**SUBJECT:** Response to Request for Additional Information Regarding Adoption of National Fire Protection Association Standard NFPA 805 License Amendment Request Waterford Steam Electric Station, Unit 3  
Docket No. 50-382  
License No. NPF-38

**Additional Information (60 day responses) in Support of NRC Review for  
Waterford 3 NFPA 805 License Amendment Application**

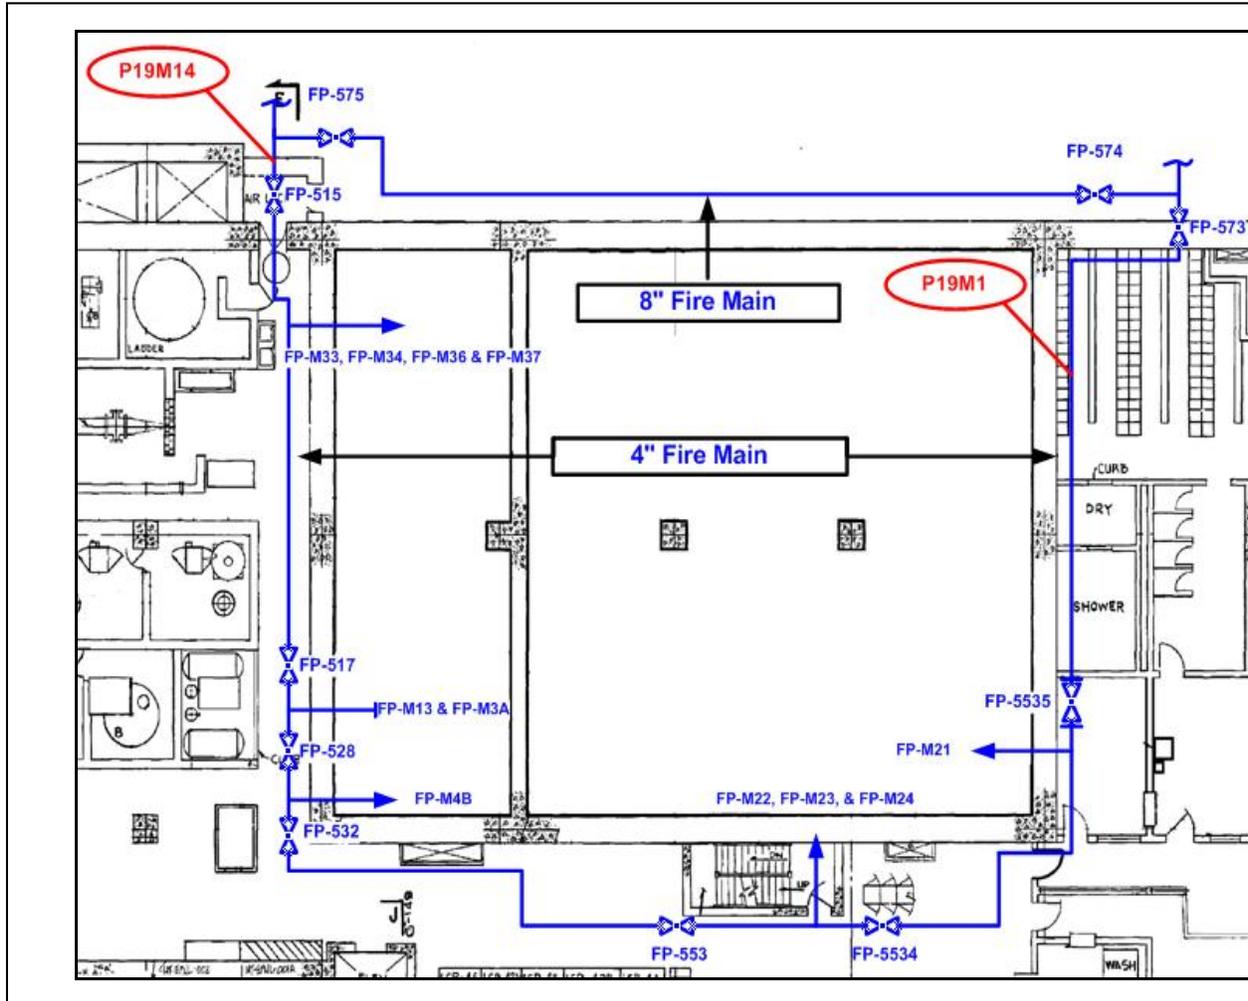
*Attachment L, Approval Request 6 -A deviation from NFPA 805 Section 3.5.1 is requested for several plant areas where the fire water supply demand is not met with the least demanding portion of the main loop out of service. Please justify this deviation to include a discussion of the following:*

- a. The location of this 4" loop section.*
- b. The procedures in place to mitigate.*
- c. The capacity of the three sprinkler systems given the least demanding portion of the main loop is out of service.*
